**NOTICE OF DISPOSITION FOR A
 PLAN COMPATIBILITY REVIEW**

Order No.:	2016-032
Case Number:	PCR16-00002
Project Type:	Plan Compatibility Review
Procedure Type:	Administrative- Director's Decision
Owners:	Catherine Fisher and Tim Dale 3020 SW Morris Ave. Corvallis, OR 97333
Applicant:	John Robinson Quality Residential Construction LLC 2500 Del Rio Ct. SE Albany, OR 97322
Site Address:	3020 SW Morris Ave.
Map and Tax Lot:	12-5-03 BD 4600
Comprehensive Plan Designation:	Low Density Residential
Zoning Designation:	RS-3.5
Planner Assigned:	Jared Voice
Application Submitted:	May 10, 2016
Application Complete:	June 3, 2016
120-Day Deadline:	October 1, 2016
Date of Decision:	June 23, 2016

The applicant has filed a Plan Compatibility Review (PCR) application with the City of Corvallis Development Services Division, requesting approval of a reduced minimum east side yard setback, from 8 ft. to 6.5 ft. The reduced setback would allow for the addition of a new exterior stairway and landing, providing direct access to the second story of the existing single family dwelling. **See Attachment A for application materials.**

ATTACHMENT A.7

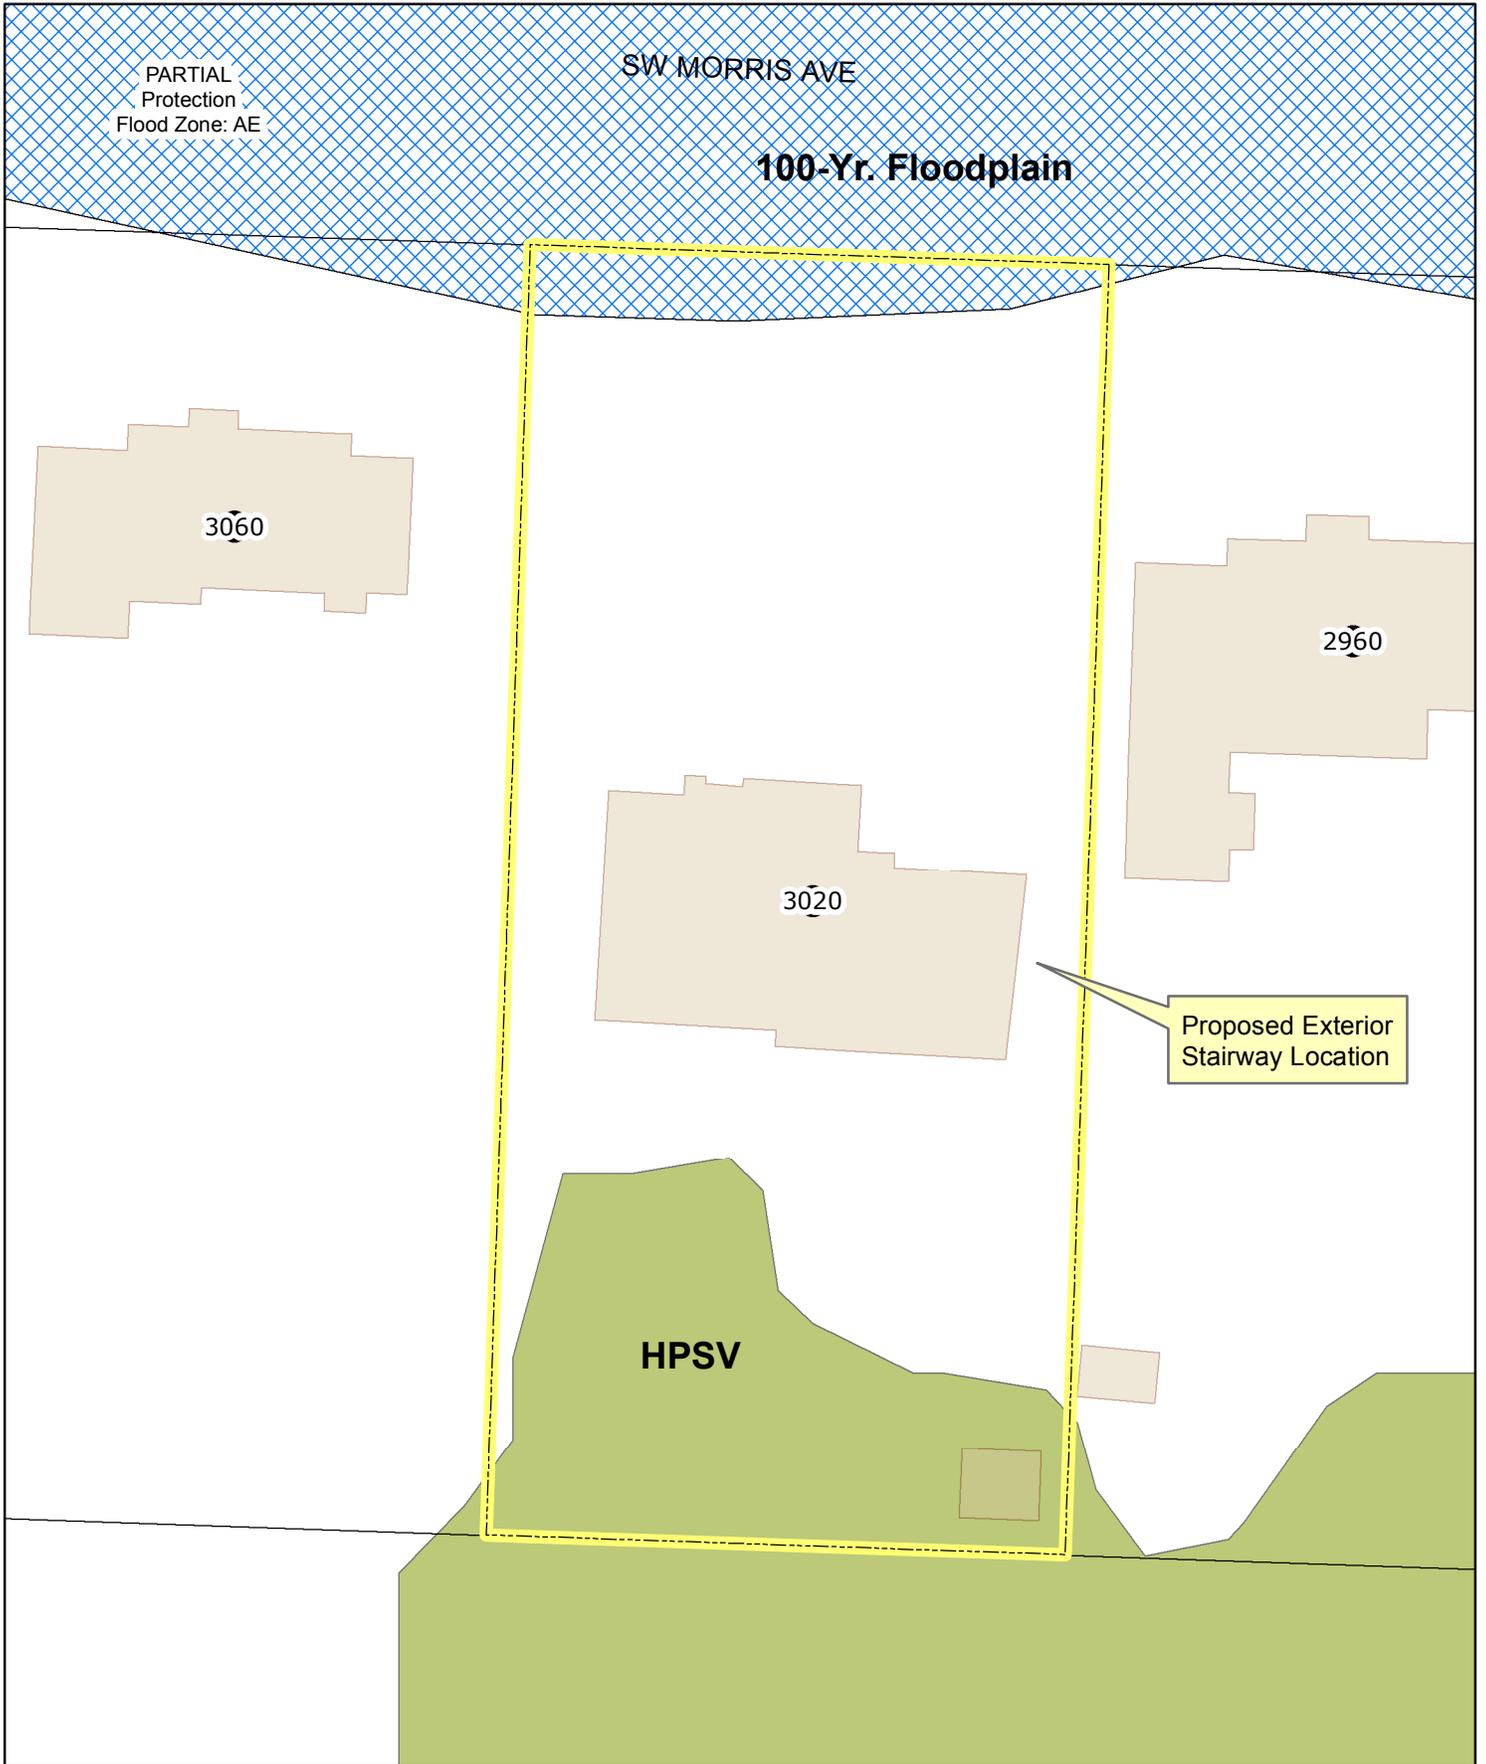
development that would be allowed outright by the Land Development Code. The proposed stairway and landscaping would have a side yard setback of 6.5 feet from the abutting property to the east (see **Attachment A.6** and **Condition of Approval 1**), which is 18 inches less than the 8-ft. minimum side yard setback typically required within the RS-3.5 zone. Elevation drawings submitted with the application (**Attachment A.7**) show that the walking surface of the landing would have a height of roughly 8.5 above adjacent grade, and the handrail would have a height of about 11.5 feet when measured to adjacent grade. The LDC would allow outright a 30-ft. overall height, if the structure were to meet the 8 ft. side yard setback. The LDC would also allow a 14-ft. tall accessory structure within 3 feet of the side property line. Both of these outright-permitted scenarios would presumably have greater visual impacts to the affected neighboring property than the applicant's proposal.

The stairway and landing width (36 inches) is the minimum necessary to comply with building code ingress / egress requirements. The stairway and landing are proposed in order to provide direct access to the second floor of the dwelling, and are not intended to serve as a deck or recreation area. Use of the stairway will be limited to persons accessing the second floor of the dwelling. It should be noted that primary access to the dwelling (including the second floor space) is provided via two street-facing front doors on the first floor. Therefore, the proposal would cause minimal noise and privacy impacts to the affected neighboring property to the east.

1. Consistency with Plans - Development shall comply with the plans and narrative in the applicant's proposal identified as **Attachment A**, except as modified by this approval or the conditions below.

ATTACHMENT B

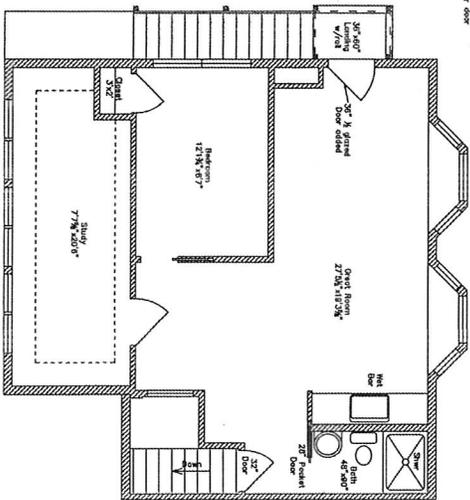
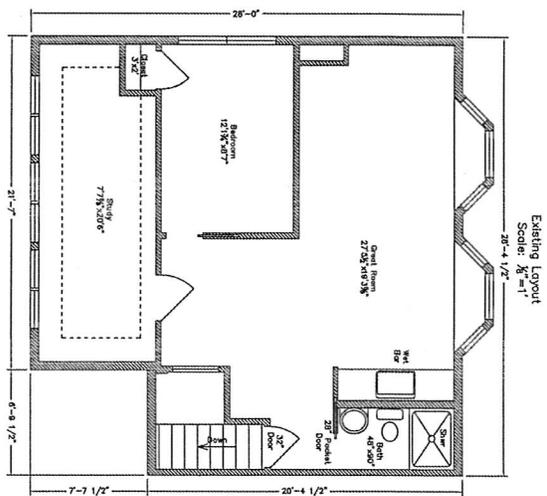
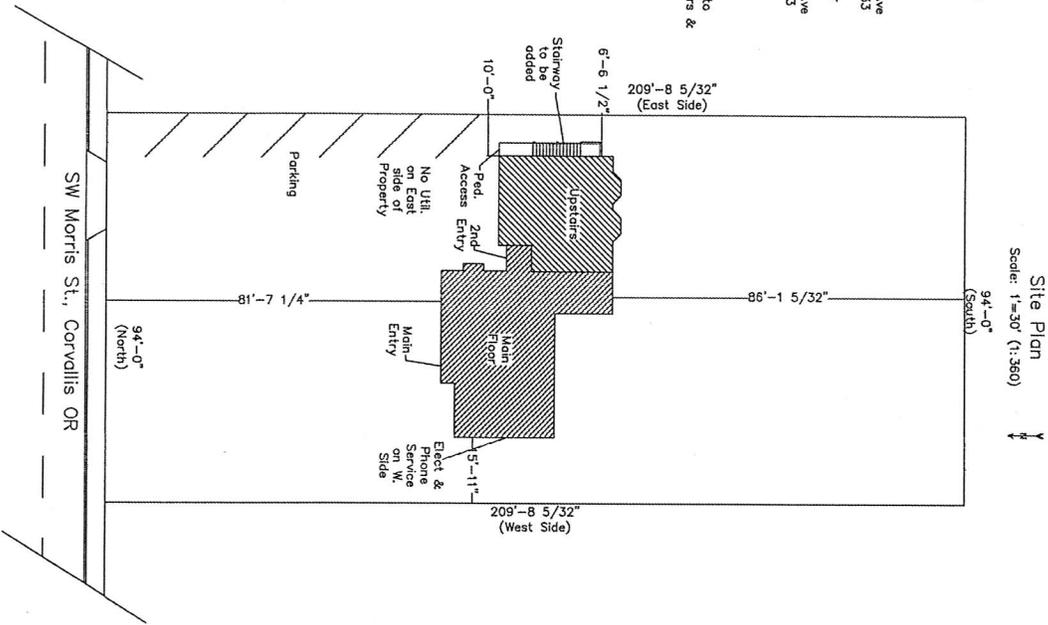
Staff Response: Satisfied With Conditions. The City's Natural Hazards overlay shows a small portion of the subject property (roughly the northern-most 11 feet) being within a mapped Partial Protection 100-year Floodplain. The mapped floodplain is at least 85 feet away from the proposed exterior stairway / landing, so no Floodplain Development Permit (FDP) will be required for its construction. As per **Condition of Approval 3**, an FDP may be required for the driveway work.

The Natural Resources overlay shows the lot's rear yard partially covered by Highly Protected Significant Vegetation (HPSV). The mapped HPSV area is well away (at least 50 feet) from the proposed stairway and landing, and is unaffected by the proposal. In addition, based on aerial photos, there appear to be several existing trees on and abutting the property. Any existing significant trees (8" caliper or greater at 4 ft. above existing grade) outside of the mapped HPSV area must be preserved to the greatest extent practicable, as per Land Development Code Sections 4.2.20.d and 4.12.60.f. **Development Related Concern A**

Original Site Plan Submittal

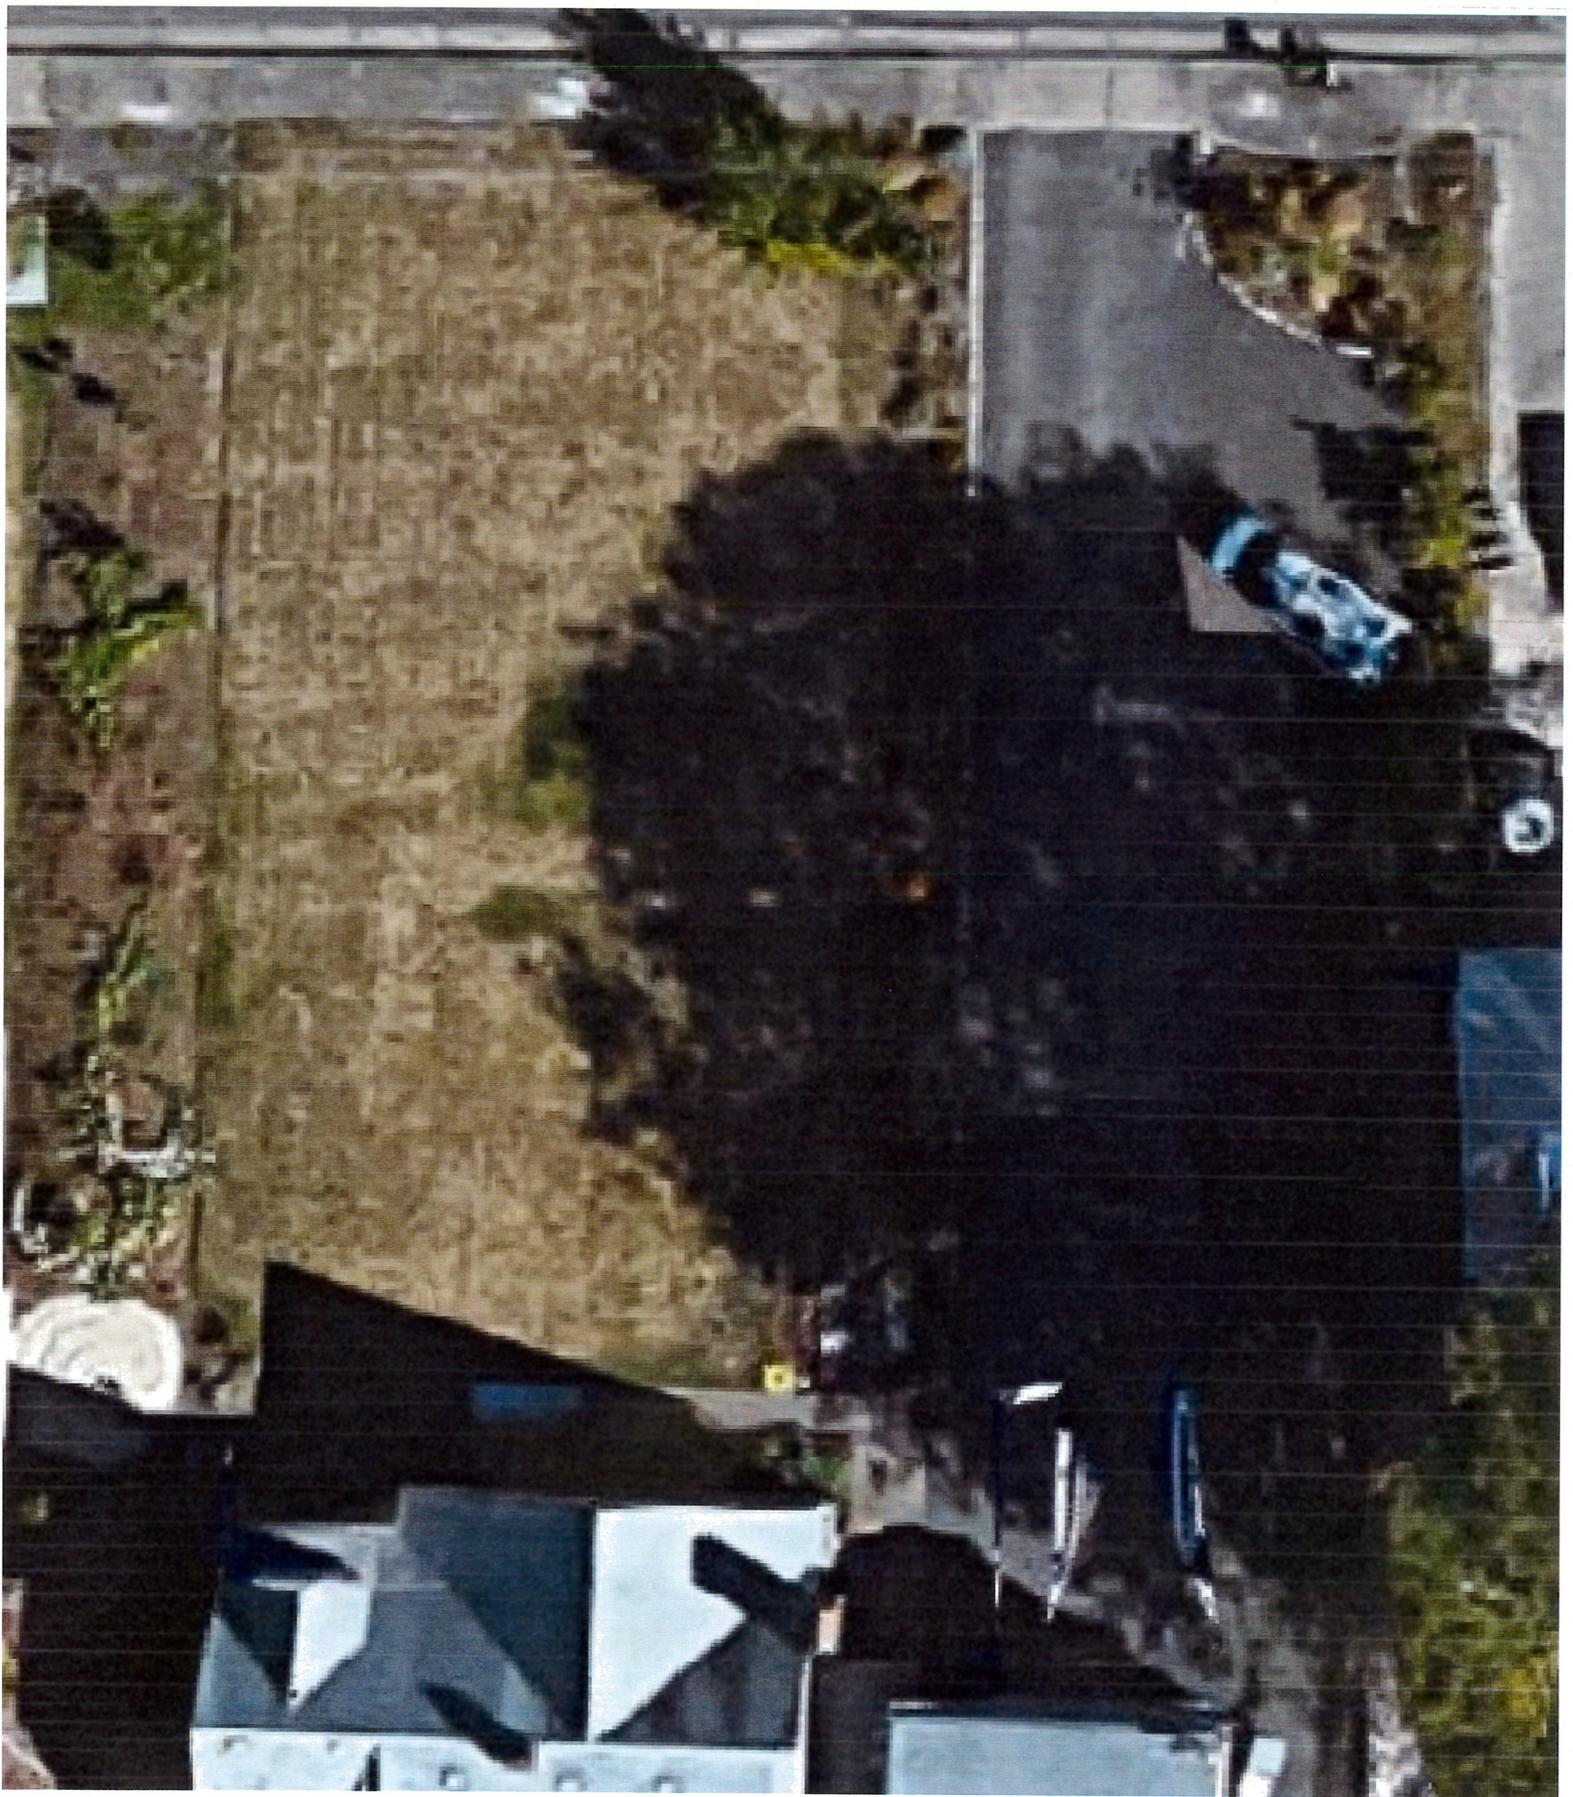
Staff Response: Satisfied With Conditions. The proposed reduced setback, for an exterior stairway and landing serving an existing single family dwelling, will have no effect on traffic, parking or access. However, during the application review process, it was discovered that an existing non-approved driveway surface has been expanded in a manner that does not comply with City standards. Gravel is not an approved driveway surface within the City of Corvallis. Gravel driveways existing prior to February 7, 1980, may remain in their non-conforming state, but may not be expanded. A site plan included with the original PCR application (**Attachment C.1**) shows angled parking along the east property line. Photo records indicate that this angled parking is located within a gravel area that was added to a previously-existing 15-ft. wide legal non-conforming driveway, at some point between 2010 and 2012. The applicant later

indicated that the angled parking shown on the originally-submitted site plan was a drafter's error, and submitted a revised site plan eliminating this parking. Per the applicant's revisions, the gravel added along the east property line between 2010 and 2012 is ground cover only, and is not used for parking / maneuvering. However, street view and aerial photos taken since 2012 (**Attachments C.2 – C.4**) appear to indicate that the expanded gravel area has been consistently used for vehicle parking and maneuvering since 2012. If the gravel is to remain on the site as ground cover only, then it must be delineated from the driveway via installation of a permanent feature, such as a curb, to prevent its continued use as an extension of the driveway. The City will be flexible in terms of what feature is actually used (a curb is not necessarily required), as long as it is permanent / immovable, and provides continuous delineation. **Condition of Approval 3** requires that the applicant submit a plan showing how the expanded portion of the driveway will be brought into compliance with City standards, either through removal, delineation from the existing driveway, or surfacing with an approved surface (asphalt, concrete, or alternative hard surfacing as approved by the City Engineer), prior to the issuance of permits for the exterior stairway. A 5-ft. minimum driveway setback from abutting properties must generally be maintained. Any driveway widening beyond the previously-existing 15-ft. wide driveway will require hard surfacing (asphalt, concrete or similar), and a 5-ft setback from the eastern property line. Note also that a driveway catch basin is required when the cumulative impervious area of a driveway exceeds 1,000 SF. Also note that work within the floodplain may require a Floodplain Development Permit.

3. Driveway Surfacing- Prior to building permit issuance for the exterior stairway and landing, the expanded gravel area of the driveway (added to the property at some point between 2010 and 2012) shall be either removed from the site and replaced with landscaping, paved with a City-approved driveway surface, or physically separated from the previously-existing legal driveway via a permanent feature such as a curb or similar feature. Any driveway widening beyond the previously-existing 15-ft. wide driveway will require hard surfacing (asphalt, concrete or similar), and a 5-ft setback from the eastern property line. Note also that a driveway catch basin is required when the cumulative impervious area of a driveway exceeds 1,000 SF. Also note that work within the floodplain may require a Floodplain Development Permit.
